# CITY OF ALBUQUERQUE

**Re: BJ Restaurant- Winrock Mall, Grading Plan for Building Permit  
Engineer's Stamp date 5-23-2012 (J19/D058A)**

**BJS BUILDING PERMIT DRAINAGE PLAN**

Sheet  
C100

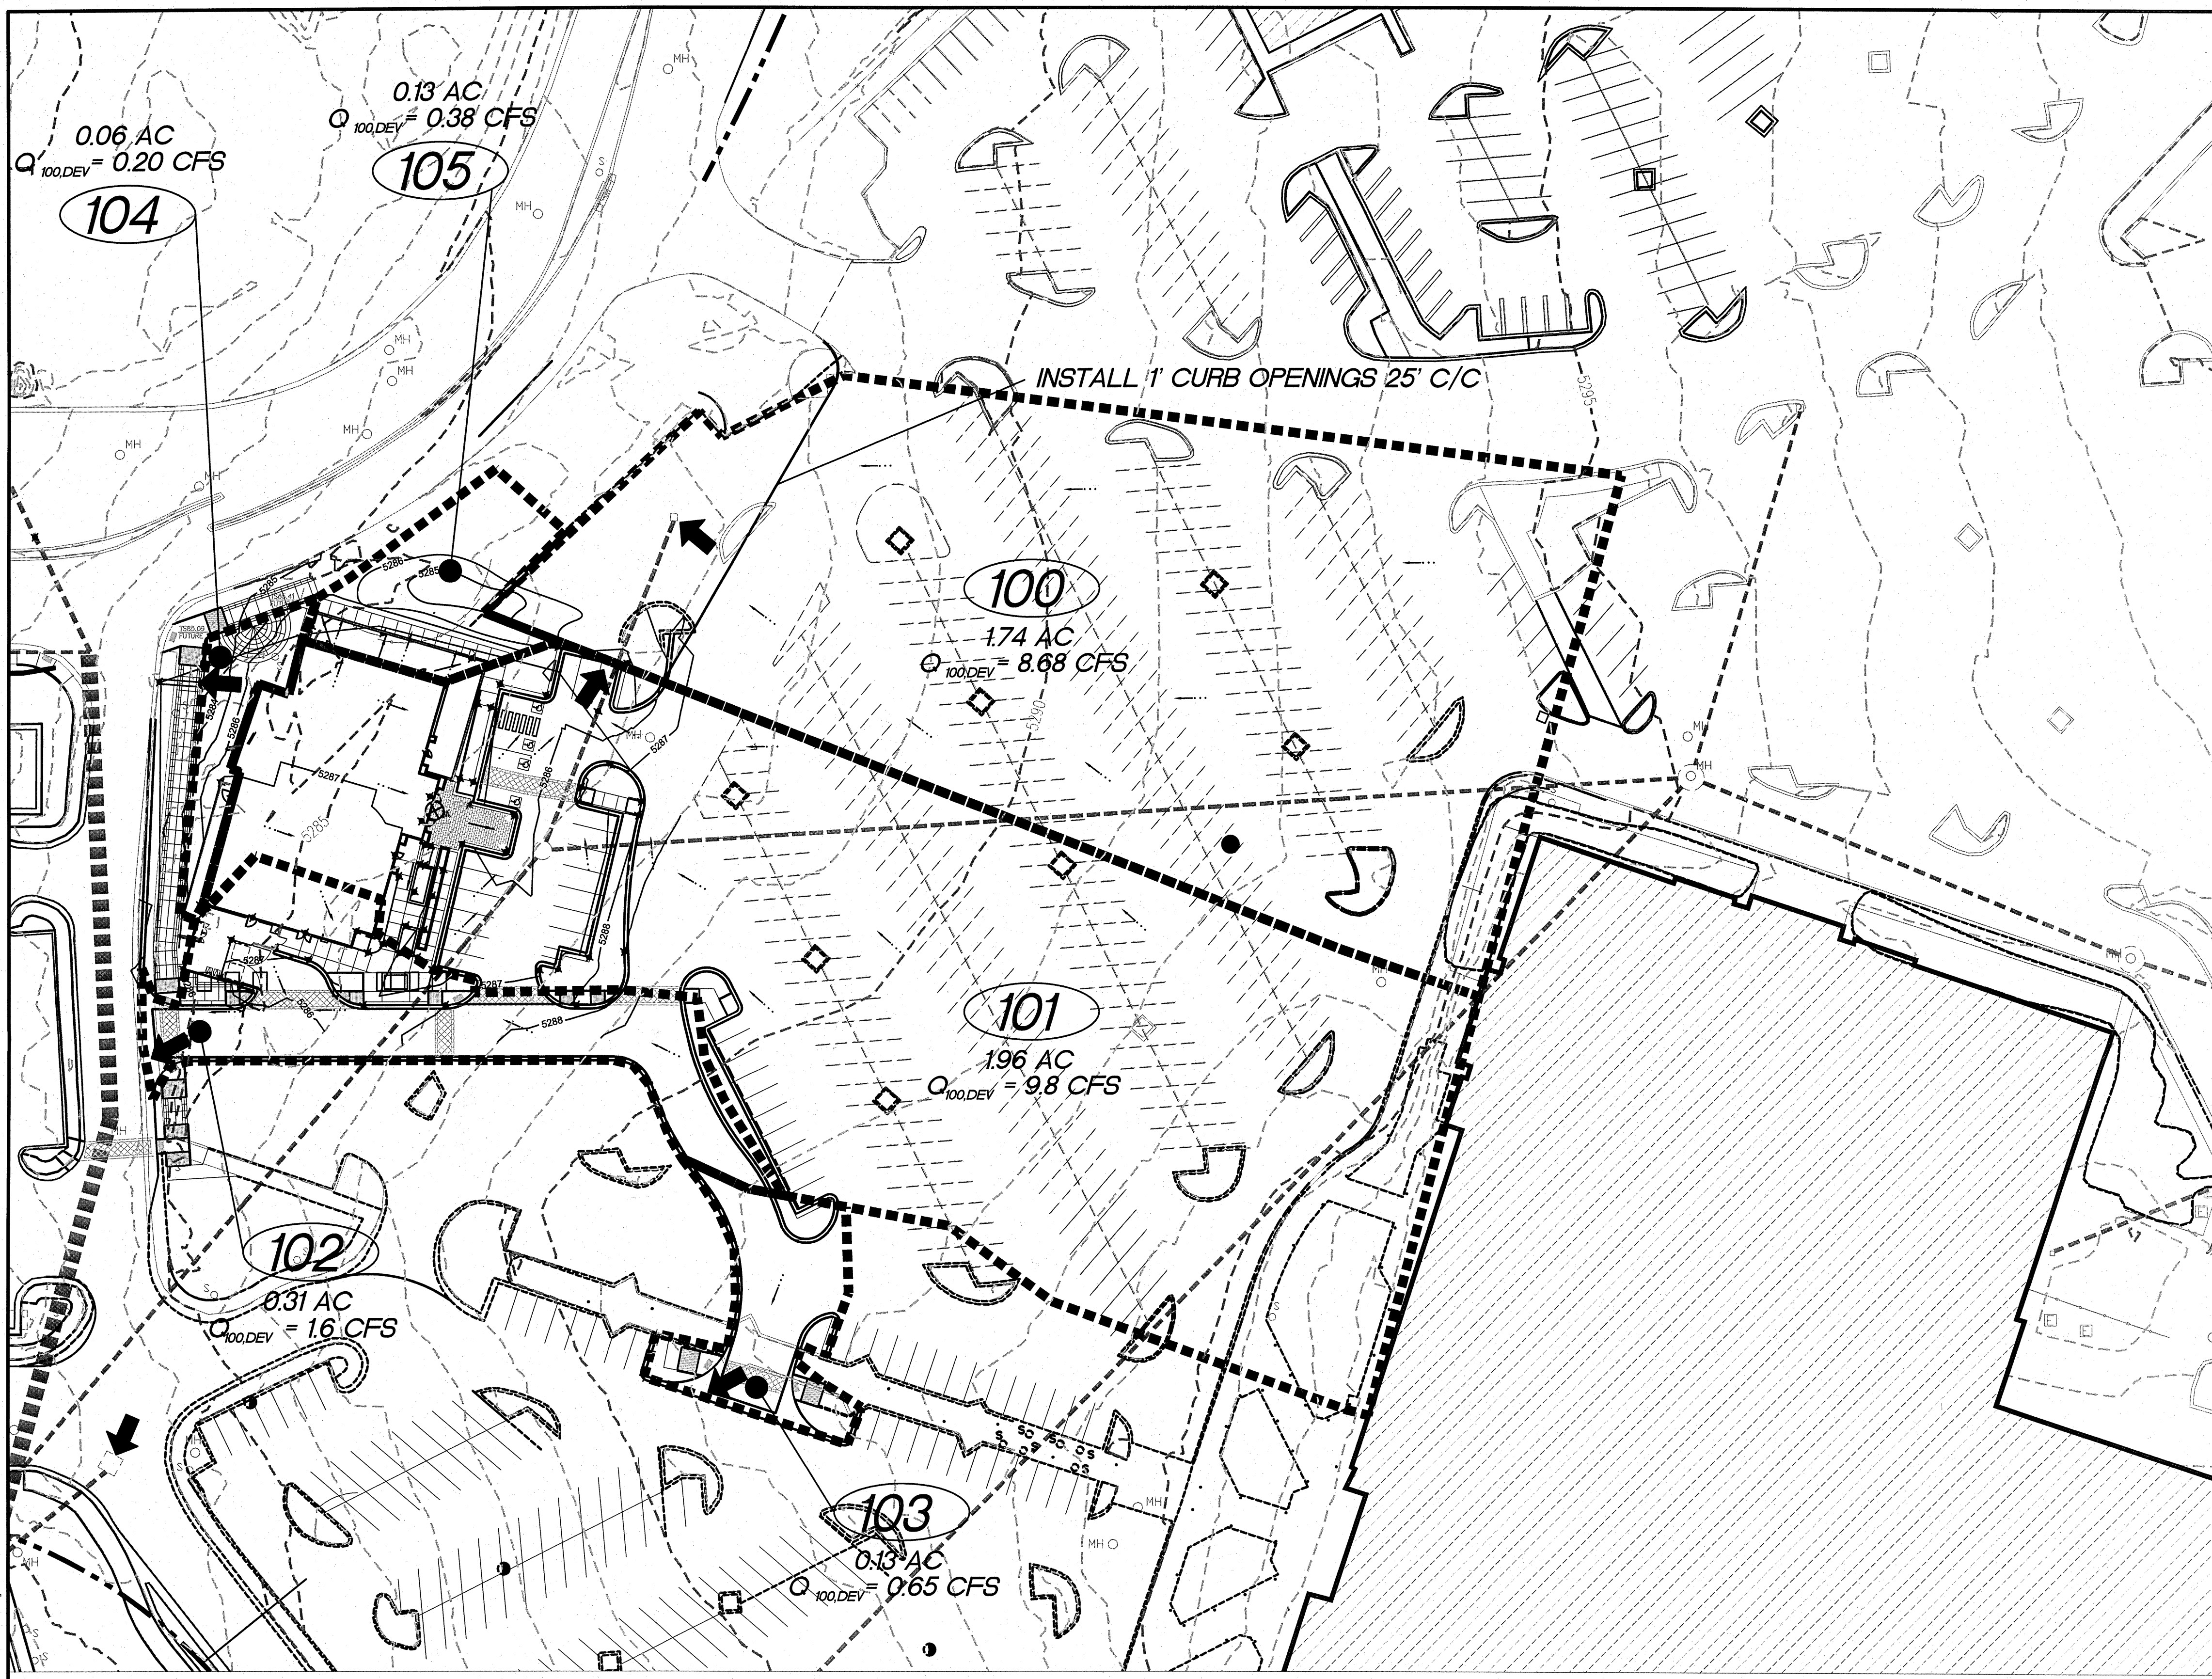
Per the DPM Chapter 22 Section 9, runoff from the trash enclosure pad is required to drain to the sanitary sewer. Per our telephone discussion, this will be shown on the utility plan for Building Permit, and must be included in your Engineer's Certification for Certificate of Occupancy.

Prior to Certificate of Occupancy release, provide this office with an Engineer's Certification per the DPM checklist, including the as-built trash enclosure drainage.
